7.0 Instrumentation and Control Systems

7.1 Introduction

The information in this section of the reference ABWR DCD, including all subsections and tables, and figures, is incorporated by reference with the following departures and supplements.

Figure 7.1-1 ~~SSLC Self-Test System~~ Diagnosis

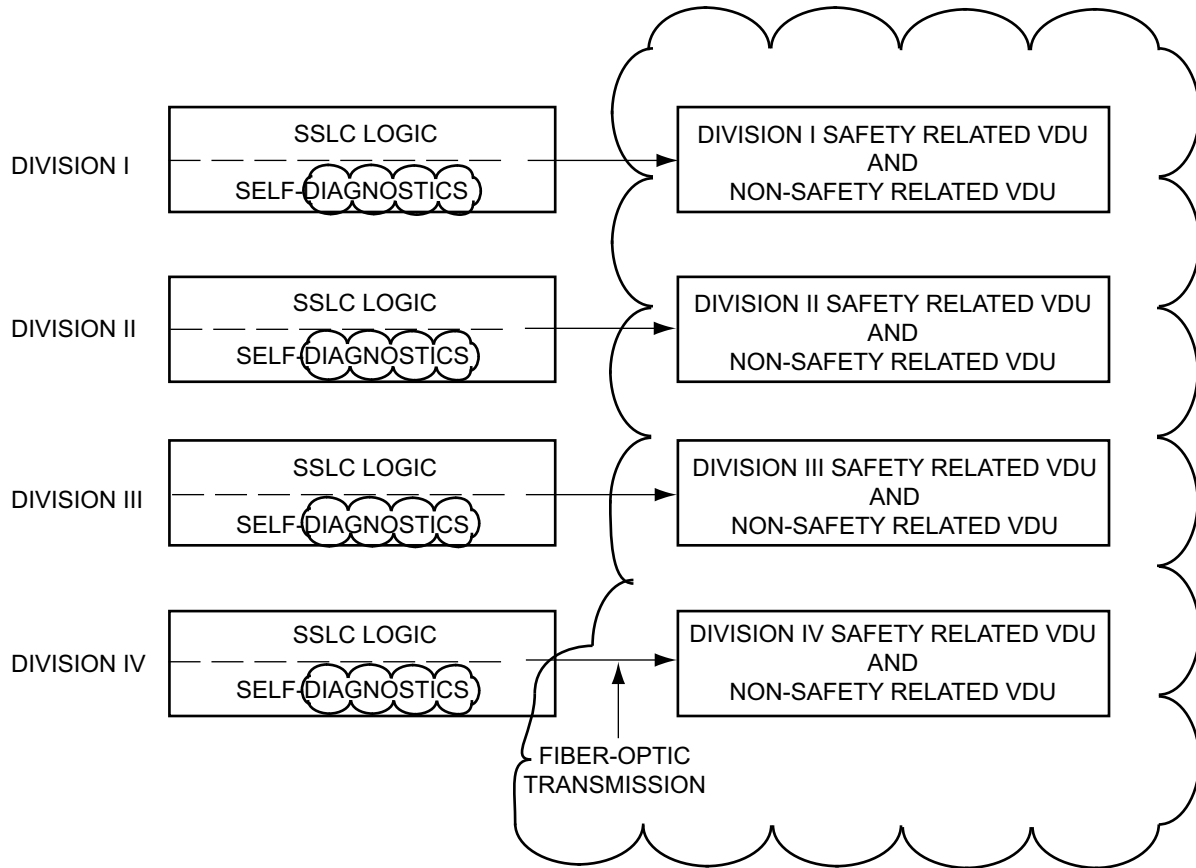
STD DEP T1 3.4-1 (Figure 7.1-1, 7.1-2)

The RPS RTIS and ESFELCS Systems can be tested during reactor operation ~~by six separate tests~~. The first five tests are primarily manual tests and, although each individually is a partial test, combined with the sixth test they constitute a complete system test. The sixth test is the ~~self~~ test of the safety system logic and control which ~~automatically~~ tests the complete system excluding sensors and actuators.

- (6) ~~The sixth test is an integrated self test provision built into the microprocessors within the SSLC. It consists of an online, continuously operating, self-diagnostic diagnostics monitoring network, and an offline semi automatic (operator initiated, but automatic to completion), end-to-end surveillance program. Cross channel comparison of sensor inputs is performed by plant computer functions. Both online and offline functions operate independently within each of the four divisions. There are no multi-divisional interconnections associated with self-testing diagnostics.~~

Figure 7.1-2 Assignment of Interfacing Safety System Logic to SSLC Controllers

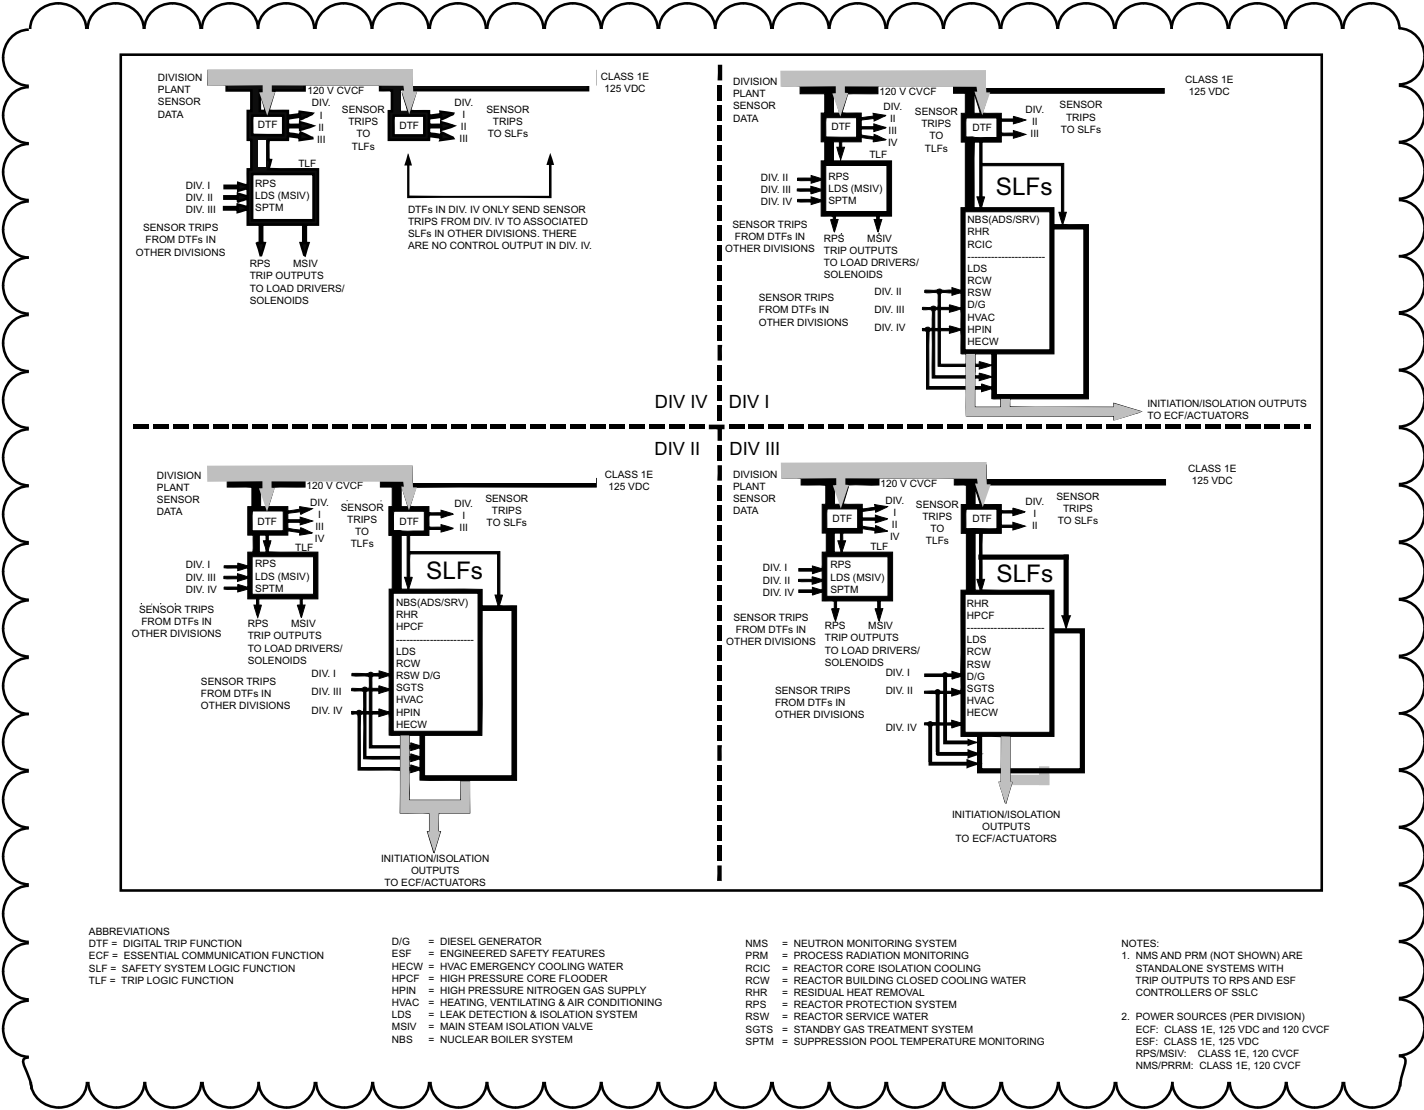
Each individual safety-related system utilizes redundant channels of safety-related instruments for initiating safety action. The automatic decision making and trip logic functions associated with the safety action of several safety-related nuclear steam supply systems (NSSS) are accomplished by ~~a four division correlated and separated protection logic complex called the~~ safety system logic and control (SSLC). The SSLC includes multiple redundant divisions, which are separated from each other. The SSLC has four redundant divisions of sensors. Each division of sensors has a corresponding division that determines the trip status of the safety functions relative to the safety function setpoint. The SSLC has four redundant divisions for all actuation functions except for the engineered safety features. The engineered safety features have three divisions, corresponding to the maximum redundancy of the engineered safety features actuated components. Some engineered safety features functions are less than three-fold redundant and are assigned to the appropriate set of redundant divisions. The SSLC multi-divisional complex includes divisionally separate control room and other panels which house the SSLC equipment for controlling the various safety function actuation devices. The SSLC receives input signals from the redundant

~~Divisional separation is also applied to the essential multiplexing system (EMS), which provides data highways for the sensor input to the logic units and for the logic output to the system actuators (actuated devices such as pump motors and motor-operated valves).~~ Systems which utilize the SSLC are include: (1) Reactor Protection (trip) System; (2) High Pressure Core Flooder System; (3) Residual Heat Removal System; (4) Automatic Depressurization System; (5) Leak Detection and Isolation System; (6) Suppression Pool Temperature Monitoring System; and (7) Reactor Core Isolation Cooling System. The equipment arrangement for these systems and other supporting systems is shown in Figure 7.1-2.
